Subject: FW: 23/01080/OUT and 23/02399/REM (NEW)

Subject: Re: 23/01080/OUT and 23/02399/REM (NEW)

I hope you are well. We have reviewed the revised arrangement for this junction (image below) and I am afraid we have some very serious concerns. I would add that we were not involved in the development of the design, otherwise we would have raised these earlier.

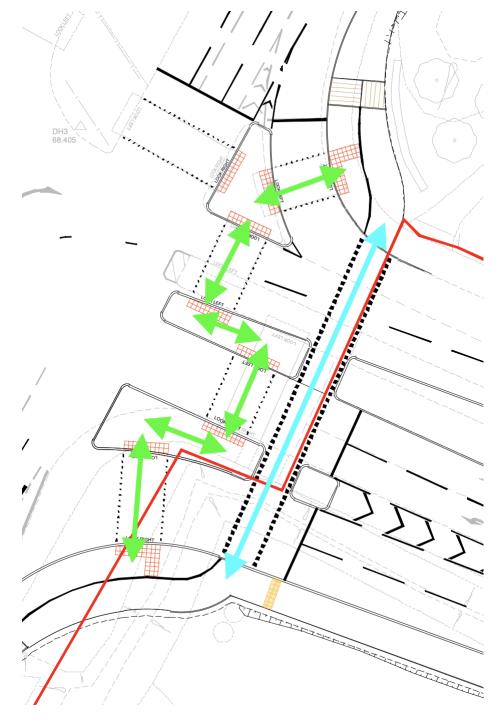
The design is a modest improvement over the initial concept in that the pedestrian and cycle crossings have been decoupled. However:

- 1. The frontage of the site is a 40mph road. LTN1/20 requires a buffer of at least 0.5m, and advises at least 1m. At present the applicant is proposing zero buffer.

- 2. The Bicester LCWIP specifies that both frontages (A41/Oxford Road & Lakeview Drive) should be segregated paths. The OCC CDS also require segregated paths alongside spine roads such as the A41. At present the applicant is proposing shared.

- 3. Though we do not have a mandate for pedestrian provision, the pedestrian crossings are truly awful and will effectively prevent anybody from walking along the A41. There are 4 separate crossings, no doubt with long waits at each crossing, each are staggered in a way that is unlikely to comply with the Equality Act as they will be almost impossible to navigate in a wheelchair, and the islands are way too narrow. Surely we could do better here, even if it was to reduce the angle offset to below 90°? Ideally the number of pedestrian crossings would also be reduced to 2 or at least 3 with bigger islands.

4. The standard arrangement of a junction is always to have the cyclists closer to the motor vehicle traffic and the pedestrians further away. This design reverses this logic and will inevitably cause conflict between pedestrians and cyclists. A better arrangement must be possible.
